The following site development standards shall apply within the boundaries of the Museum Market PlazaDowntown Palm Springs Specific Plan.

City of Palm Spi	
Downtown	Palm	Springs Specific Plan
Section III Deve	dopme	nt Standards and Guidelines

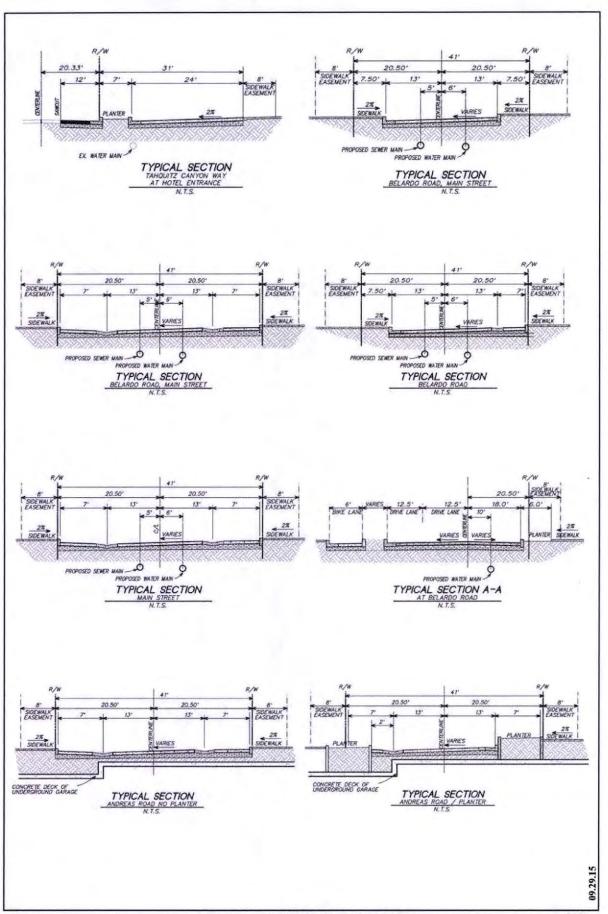
1671	4. Belardo Road
1672	
1673	Belardo Road will be extended through the Specific Plan area with a 6241 foot right of way, to
1674	allow one lane of travel in each direction, and angledparallel parking on each side. A 12
1675	
1676 1677	5. Andreas Road
1678	Andreas Road will be extending across Palm Canyon Drive to Belardo Road within a 41 foot
1679	right of way, allowing one lane of travel in each direction, curb-adjacent landscaping and a
1680	sidewalk.
1681	
1682	6. — 5, Museum Drive
1683	
1684	Museum Drive will be 48-41 feet of right of way, with a single lane of traffic in each direction,
1685	and parallel parking adjacent to the Specific Plan frontage. A 12 foot sidewalk will be provided
1686	adjacent to the Specific Plan.
1687 1688 1689	——————————————————————————————————————
1690	Museum DriveMain Street will be 4841 feet of right of way, with a single lane of traffic in each
1691	direction, and parallel parking adjacent to the Specific Plan frontage. A 12 foot sidewalk will be

1692	provided adjacent to the Specific Plan. The alignment of Museum WayMain Street will begin in
1693	front of the Palm Springs Art Museum and run due east, initially terminating at Palm Canyon
1694	Drive, and potentially (at build out) through Block K, and terminating at Indian Canyon Drive
1695	across from the former Spa Hotel site.
1696
